East Waterway OU

Anthropogenic Background Small Working Group Meeting #6

December 18, 2020; 9 – 10 am

Particle Size and Mass Balance Calculation

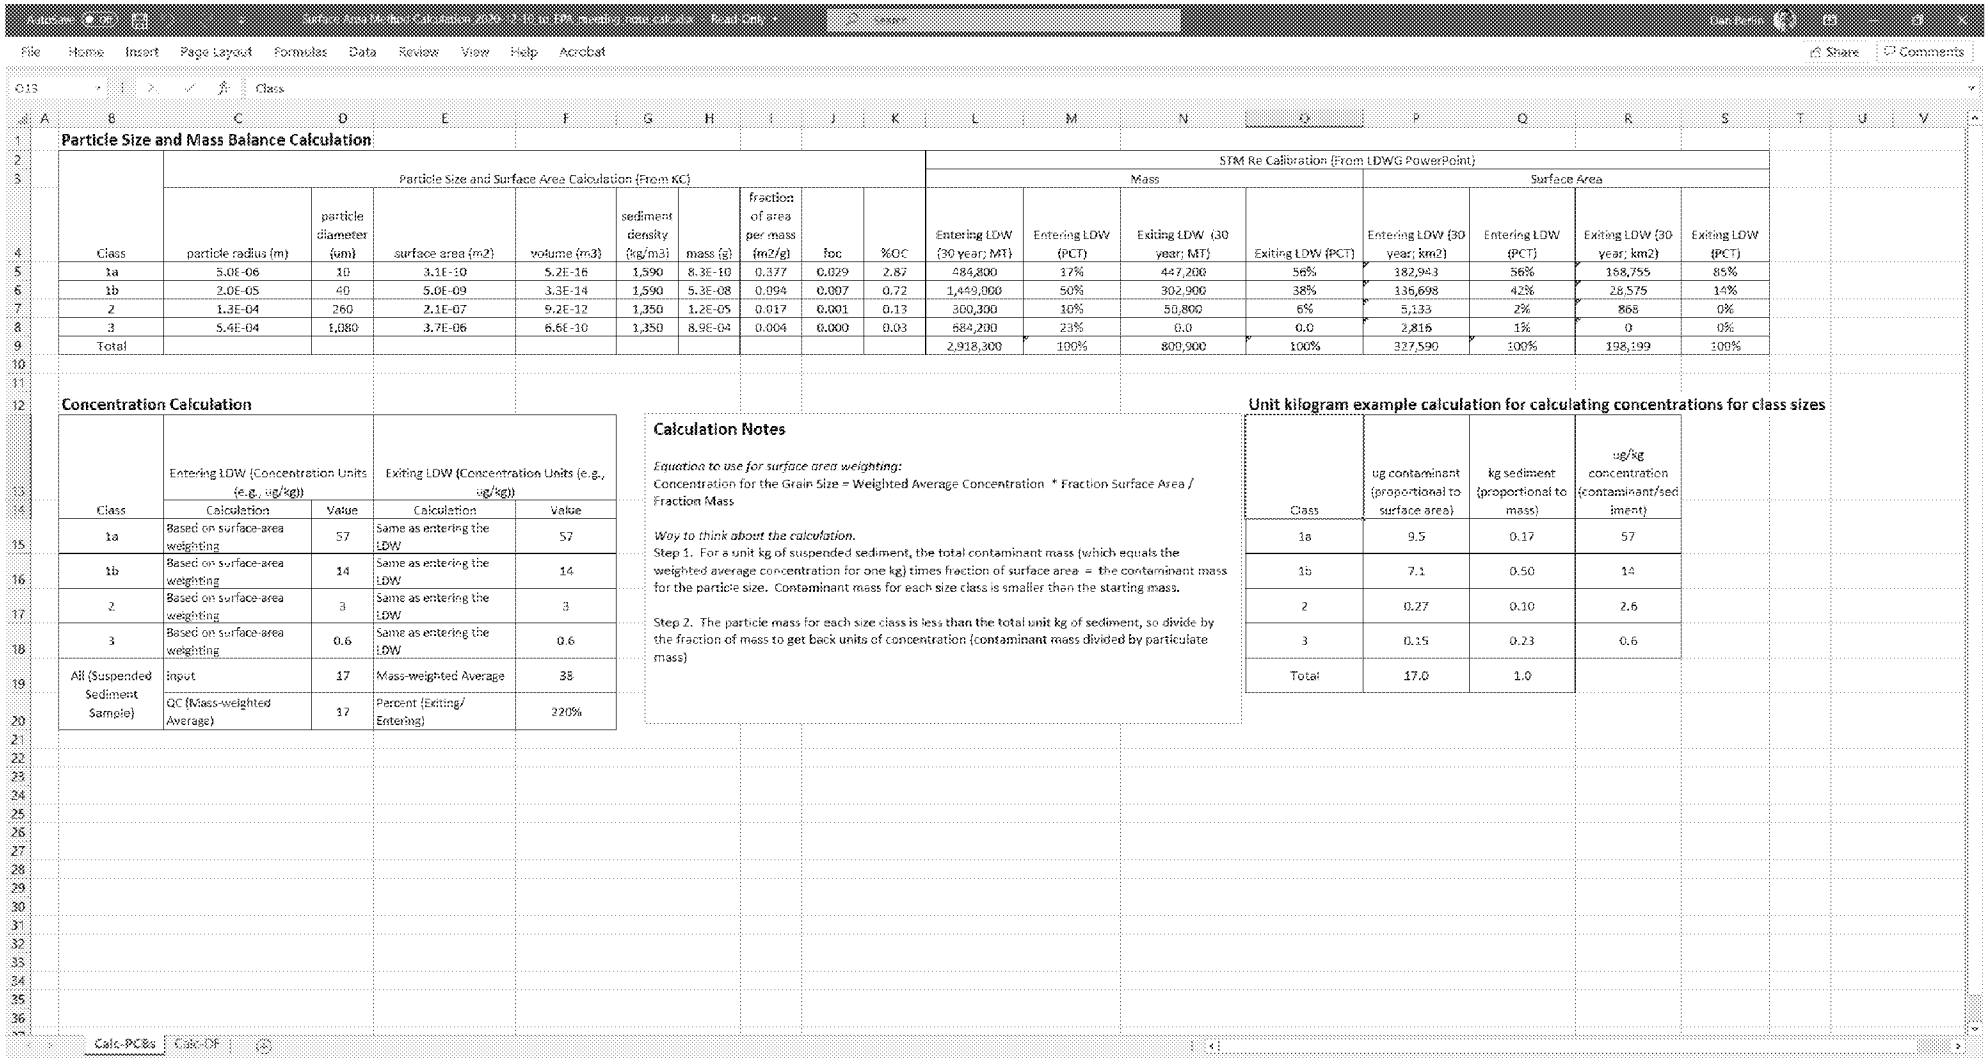
Elizabeth: I made it through the spreadsheet, and I'm a bit confused about a few things. I subscribe to the theory that this should change the result, but this changed the result a lot. So, if that's the case, I'd like to understand it better. It would be great if you can explain it further.

Bill: I think I understand surface area is used in one place and mass is used in another. It would be helpful to walk through the intermediate steps. It's probably the one factor that makes the biggest difference in the values, but it's something we are talking about right at the end of this process, so we'd like to talk more about it. It's a little bit of a novel approach, so walking through the spreadsheet step by step would be helpful.

Bill: This spreadsheet is telling us that because of the differential settling of each particle, the heaver fractions that have lower concentrations are dropping out and settling in LDW. By the time it gets to the EW, there are more small particles that have higher concentrations. If we apply it to AB for EW, why am I expecting these particles to settle in EW? Will there be differential settling within the EW?

Bill: When we look at the different grain size fractions, a certain percentage of the surface area is Class 1a, 1b, 2, or 3. But then you're using mass in a different part of the calculation, which is confusing. Can you explain why we're using both mass and surface area?

Elizabeth: we have it, but not the exercise Greg added in Columns P through R on the call today. The thing I want to point out is that concentration to mass is always directly proportional to concentration and volume. Carbon doesn't get used, but the calculated carbon content of Class 1a is much smaller than the next class (1b), which should change the density, and that doesn't get accounted for. That may not change it much, but it does change it. The other larger problem in my mind is that it makes sense in theory, but it remains theory without some empirical data backing it up. So, it's more of a consideration that these are the things that could affect it and much less of a factor as something we should use it for a calculation. Any dataset is always subject to uncertainties. We agreed that the suspended sediment dataset is most representative of what could get into the EW, but what this is saying is concentration to volume equals mass, which results in a pretty big difference. This difference supports use of this as an error bar rather than something we would use to derive AB. We have not discussed it internally. This is just my opinion at this point.

Elizabeth: Yes. I expect you would use this as part of the sensitivity analysis anyway. I would like a discussion of the theory of concentration with surface area to mass. That surface area relationship is independent of organic carbon. As the fraction of OC on the particle increases, that will have a wider

mass. This is a good theory, and it's an interesting exercise, but we don't have anything that's actually resembling this concentration differential in actuality, and that's what troubles me.

Greg: Looking at the calculations, this is a geometry problem. It's a surface area to volume problem. This was taken from an analysis that King County had performed. The fractional area per mass, which is surface area to mass ratio. As particle sizes are smaller, it's a greater surface area to mass ratio. In columns L through S, it's using the STM. We looked at what entered the LDW and what exited the LDW. What enters the LDW is a proxy for what is suspended in the Green. Columns L and N come directly from the STM, and M and O are percentages as the other columns are 30-year metric ton value. Then we use column I to get column P, which is surface area of particulate entering the LDW measured in km^2. We also estimate the surface area exiting the LDW, and calculated percentage in Column S, which we presented in the last presentation. *[see screen shot of spreadsheet on last page of these notes]*

Greg: We have to translate this to what is settling and staying. In the below table in the spreadsheet, we used the centrifuge and filtered solids samples. The basic concentrations here use the percentages in Column S from above. We're assuming the organic contamination is associated with surface area, and the overall mass of the sample (kg) would be consistent with the percent of mass, and the contaminant is calculated by taking the input concentration and dividing the sample by the percentages. This is the same relationship as fraction of organic carbon. Row 20 is for QC.

Greg: if you use microgram (ug) of contaminant per kilogram (kg) of sample, 17 ug would be distributed according to the surface area. But then you can translate that distribution into a fraction of mass. So if you then divide the ug of contaminant by the kg of sample, you get ug/kg concentration.

Greg: So on with the calculations. Exiting the LDW, the assumption is that concentration vs particle size stays the same and then we are just running a mass weighted average based on new distribution of grain sizes from the STM. You are putting your fingers on where there are some uncertainties about some of these assumptions.
